SUBJECT: Recall Campaign 092 - Stop Lamp Switch Replacement - TSB# 09-01-018

Group		CAMPAIGN
		Number		09-01-018
Subject		Date		JUNE, 2009
		Model		SEE BELOW
STOP LAMP SWITCH REPLACEMENT (CAMPAIGN 092)				
CIRCULATE TO:	<input type="checkbox"/> GENERAL MANAGER	<input checked="" type="checkbox"/> PARTS MANAGER	<input checked="" type="checkbox"/> TECHNICIAN	
<input checked="" type="checkbox"/> SERVICE ADVISOR	<input checked="" type="checkbox"/> SERVICE MANAGER	<input checked="" type="checkbox"/> WARRANTY MGR	<input type="checkbox"/> SALES MANAGER

This TSB describes the procedure to remove, replace, and adjust the stop lamp switch.

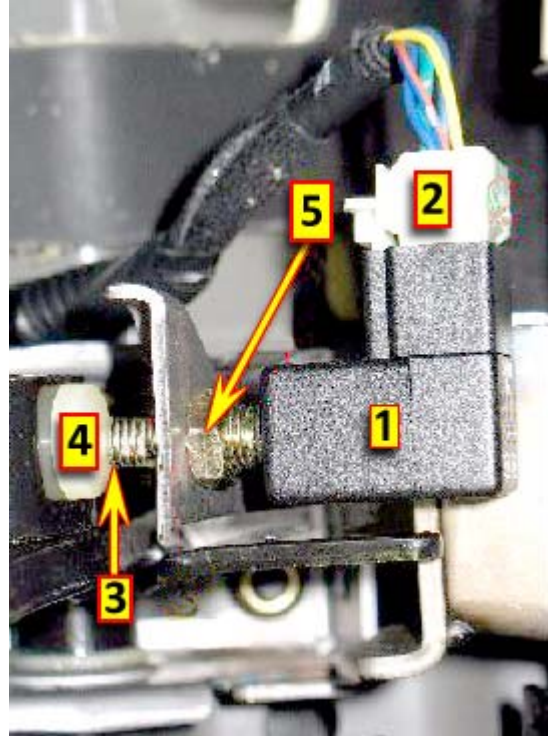
Part Name	Figure	Part Number		Remark
		Previous	New	
Switch Assy - Stop Lamp		93810-3K000	93810-3K000QQH	Connector body color change: Black (previous) -> Gray (new) For MC, HD, NF/ NFA, TG, JM, EN, and 3.3L CM/ CMA
		93810-38110		
Service Kit - Stop Lamp Switch		93810-0W000 (3.3L CMA)	93810-0W000QQH (3.3L CMA)	Stop lamp switch & extension wire 2.7L CM/CMA
			93810-3K300QQH (2.7L CM)	
Switch Assy - Stop Lamp			93810-3K400QQH	Switch and connector color: Black (previous) -> Gray (new) For EP
